# Kent County

### STAFF RECOMMENDATION REPORT June 14, 2018

<b>Application Number</b>	:	S-18-01
<b>Preliminary Plan Title</b>	:	Dollar General Forrest Ave.
<b>Present Zoning District</b>	:	BN (Neighborhood Business)
<b>Present Use</b>	:	Agriculture
<b>Proposed Use</b>	:	9,100 Square Feet Retail
<b>Relation to Growth Zone</b>	:	Outside
<b>Area and Location</b>	:	3.41 acres $\pm$ on the northwest corner of Forrest Ave. (DE Rt. 8) and Winding Creek Rd. (Co. Rd. 159), west of Dover
<b>Water &amp; Sewer</b>	:	On-site Well & Septic

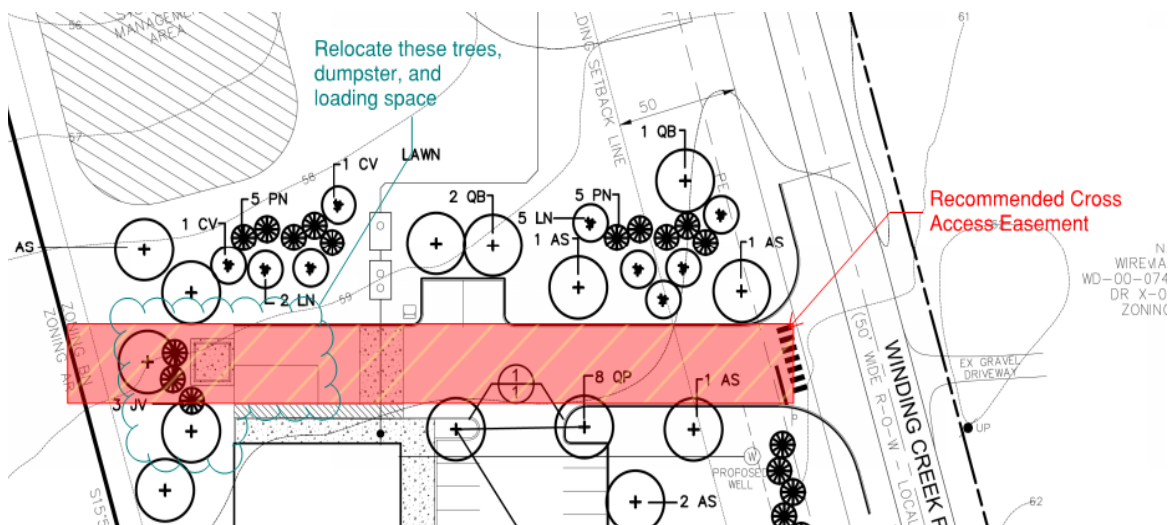
To satisfy this recommendation and to anticipate the development of the parcel to the west of the subject site, the staff recommends that a connection to this parcel be designed as part of this site plan. This would remove the need to have a new entrance be located on Halltown Rd. for any future development and help retain the current operating condition of the Rt. 8 corridor. The most appropriate way for this to occur would be to use the entrance and drive aisle from Winding Creek Rd. and extend it past the building to the residual lands owned by P. Lloyd and David E. Sheats. To do this, the site plan should relocate the dumpster enclosure and proposed tree plantings to not block this direct access to the neighboring lot. The paving to the lot line would not need to be expanded as part of this design, but a cross access easement should be recorded from the entrance on Winding Creek Rd. to the property line in anticipation of this being built in the future. The plan should also designate a potential future location for the loading space. See sketch below outlining this recommendation.
